**Subject:** Modification of the airbrakes

**Concerned:** G 103C TWIN III ACRO, S/N's 34171 - 34185

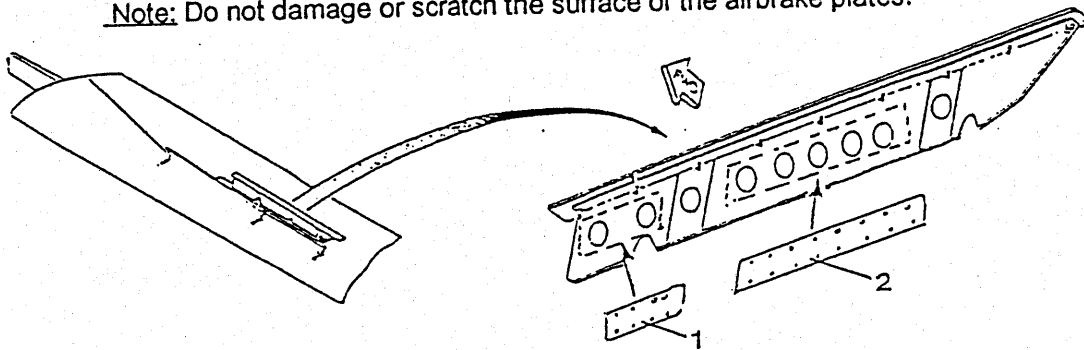
**Procedure:** Airbrakes with holes in the airbrake plates are installed in the sailplanes with the above S/N's, contrary to the type specification. To assure the airbrake efficiency in the speed range of  $V_{NE}$ , a modification to the airbrakes is mandatory.

**Actions:** The airbrake plates must be modified as follows (hole blanking):

1. Extend airbrakes fully, lock airbrakes and secure against unintentional retraction.
2. Position blanking plates from the front (smaller [1] inboard, larger [2] outboard) on the airbrake plates (10 mm below and 10 mm left or right of the edge of the holes) and secure blanking plates (note the countersunk holes in the blanking plates face forward!).

3. Drill the airbrake from the holes in the blanking plates using a 3.1  $\varnothing$  drill. Remove blanking plates and clean.
4. Rivet the blanking plates with aluminium countersunk rivets, size 3x8.
5. Clean airbrake box from swarf and all foreign objects.
6. Perform function test of airbrake control.

- drill the airbrake plates using a 3.3  $\varnothing$  drill
- rivet the blanking plates with rivets, size CCR 264CS4-4
